CITY OF KELOWNA

MEMORANDUM

Date: September 14, 2021
File No.: Z21-0088
To: Planning and Development Officer (KB)
From: Development Engineering Manager (RO)
Subject: 1225,1245 Findlay Rd RU1 to RM3

THE NEST AT FINDLAY

Plot Date 20-Dec-21	Drawing No. A-001
PROJECT FINDLAY TOWNHOMES	
DRAWING TITLE SITE PLAN & PROJECT INFO

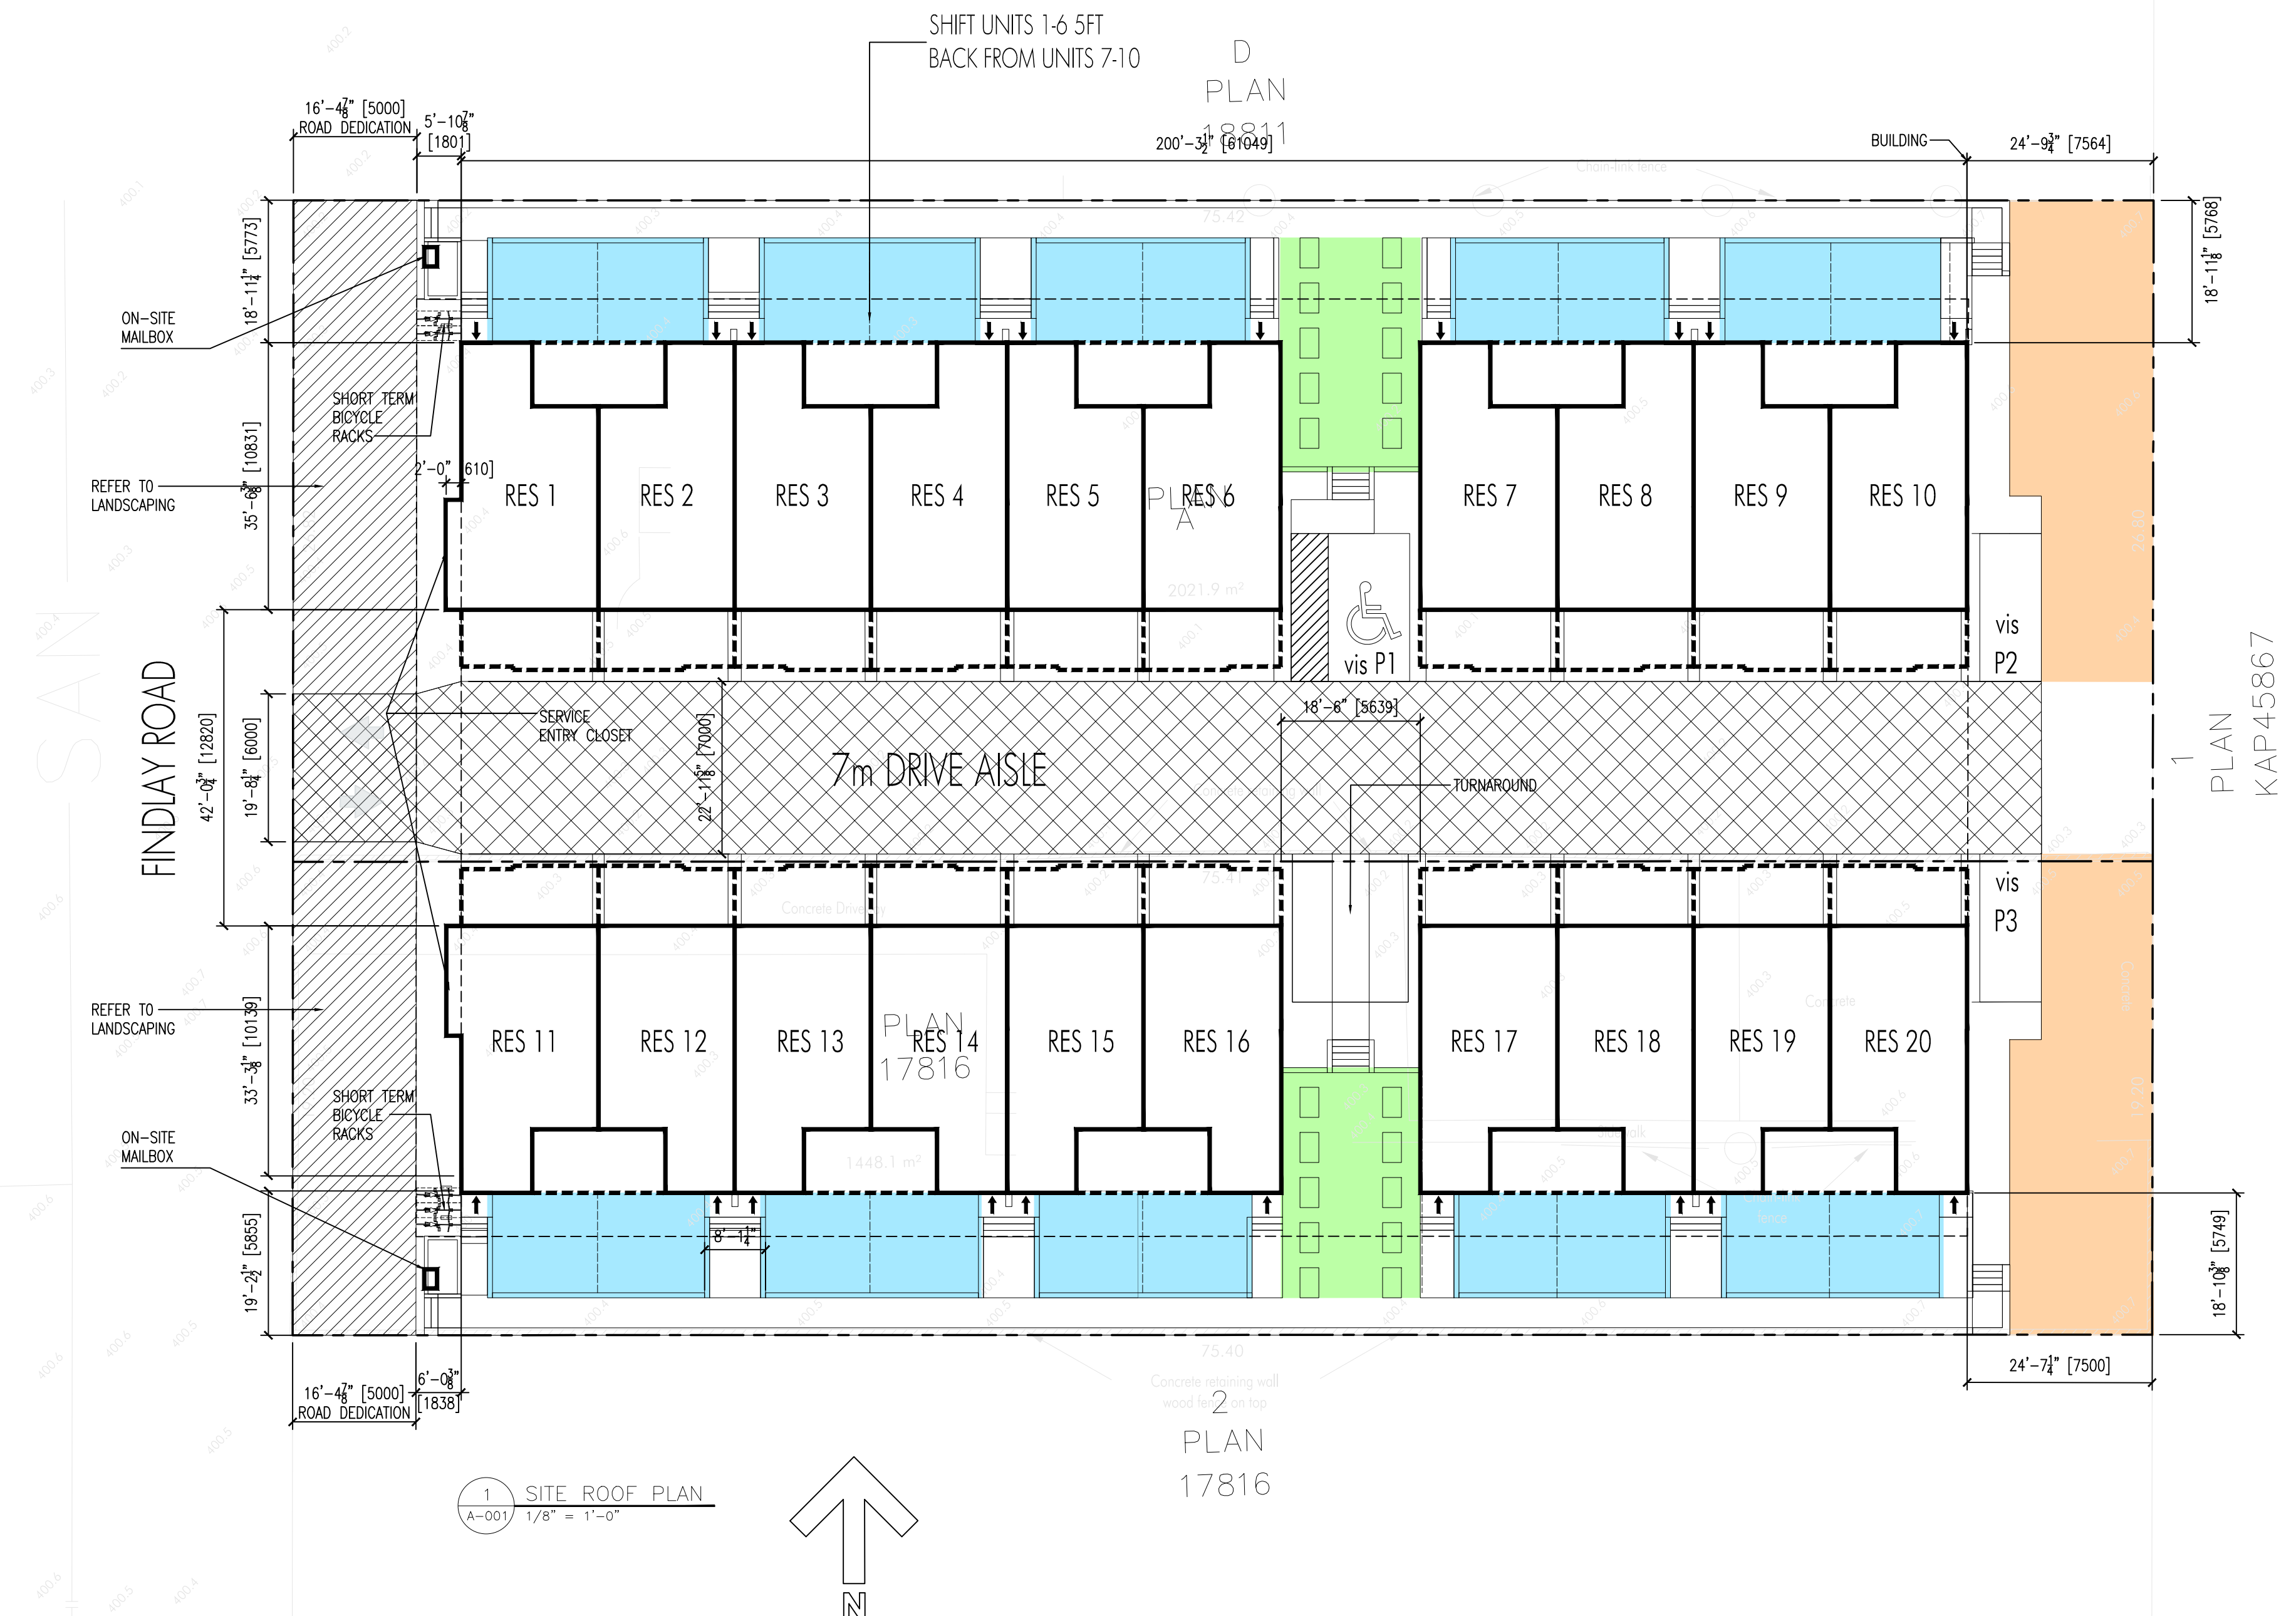
- a. Approximately 5.0m dedication along the entire frontage of Findlay Rd is required to achieve a ROW width of 25.0m.
- b. Only one driveway will be permitted with a maximum width of 6m.
- c. Indicate on the site, the locations of the garbage and recycle bins. Provide turning movements for a MSU vehicle to confirm manoeuvrability on site without requiring reverse movement onto Findlay Rd.
